SUBJECT: PRELIMINARY CERTIFICATE OF COMPLIANCE AND SAFETY EVALUATION REPORT FOR
STANDARDIZED NUHOMS[®] SYSTEM 61BT AMENDMENT (TAC NO. L23137)

**SAFETY EVALUATION REPORT
ADDITION OF THE NUHOMS[®]-61BT DRY SHIELDED CANISTER
AND ADDITIONAL FUEL TYPES**

**DOCKET NO. 72-1004
MODEL NOS. STANDARDIZED NUHOMS[®]-24P, -52B, AND -61BT
TRANSNUCLEAR WEST, INC.
CERTIFICATE OF COMPLIANCE NO. 1004**

NUHOMS®-61BT Dry Shielded Canister
Figure 1

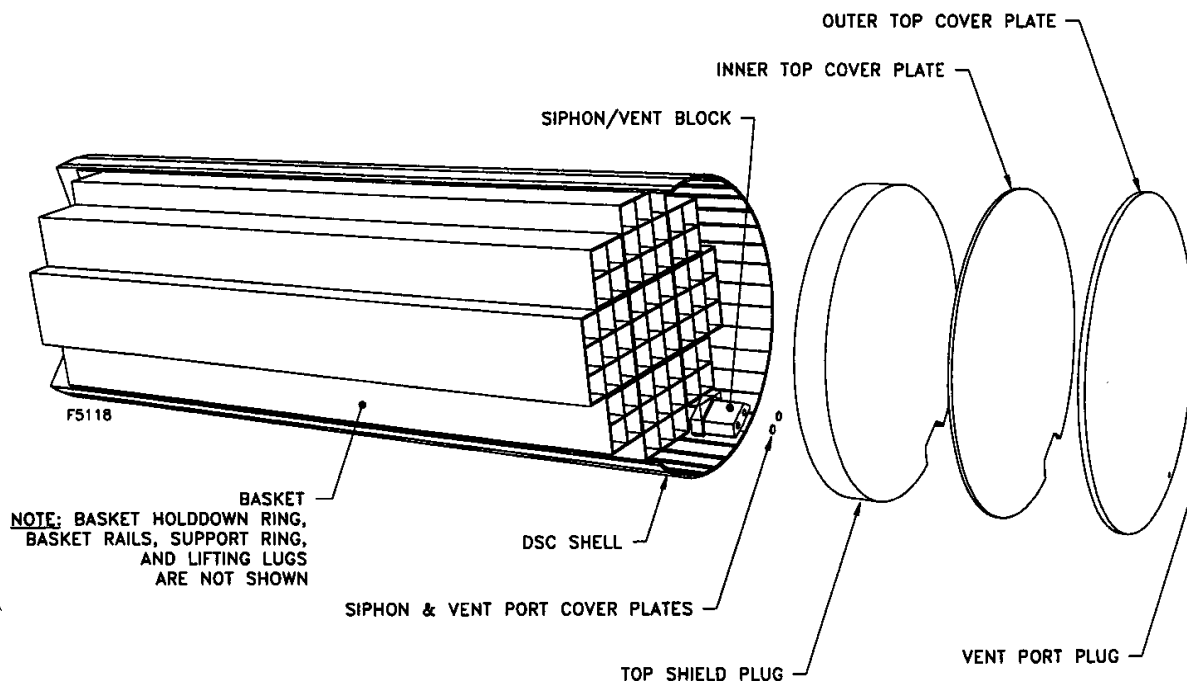
The NUHOMS®-61BT DSC, shown in Figure 1, is a new DSC design which consists of a fuel basket and canister body. Borated aluminum or boron carbide/aluminum metal matrix composite plates provide criticality control and heat conduction paths from the fuel assemblies to the cask wall. The canister shell thickness has been reduced from the NUHOMS®-52B by 0.125 inches to 0.500 inches and the welded closure has been upgraded to leak tight.

NUHOMS®-61BT Dry Shielded Canister
Figure 1

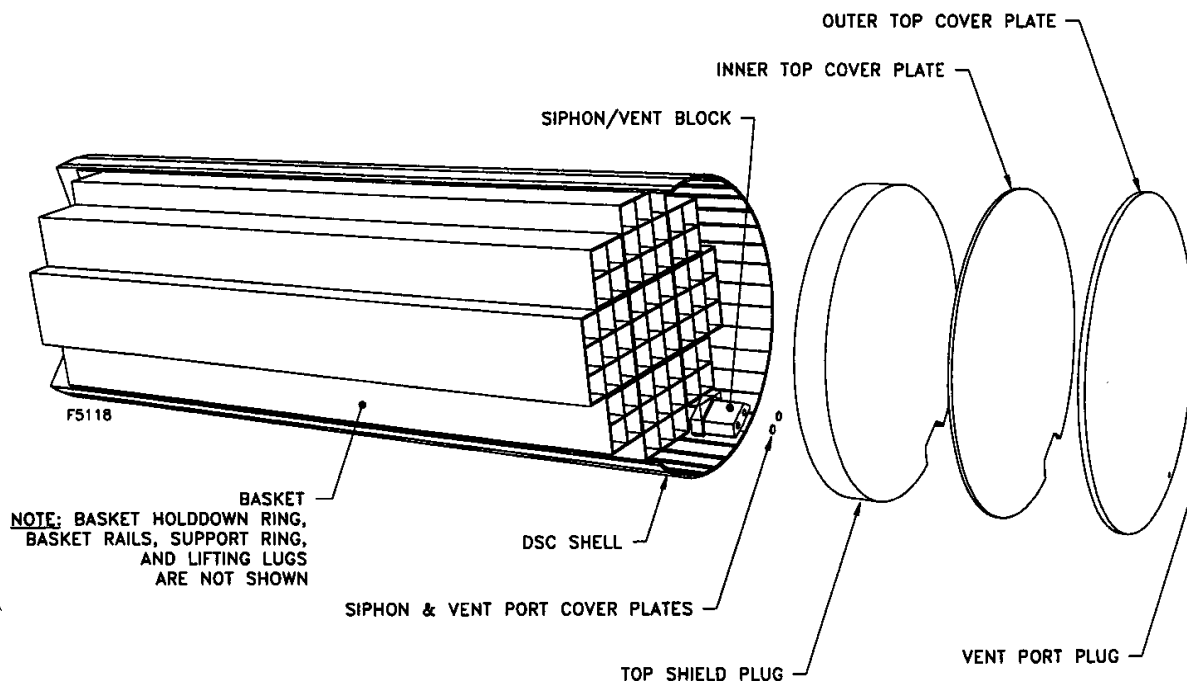
The NUHOMS®-61BT DSC, shown in Figure 1, is a new DSC design which consists of a fuel basket and canister body. Borated aluminum or boron carbide/aluminum metal matrix composite plates provide criticality control and heat conduction paths from the fuel assemblies to the cask wall. The canister shell thickness has been reduced from the NUHOMS®-52B by 0.125 inches to 0.500 inches and the welded closure has been upgraded to leak tight.
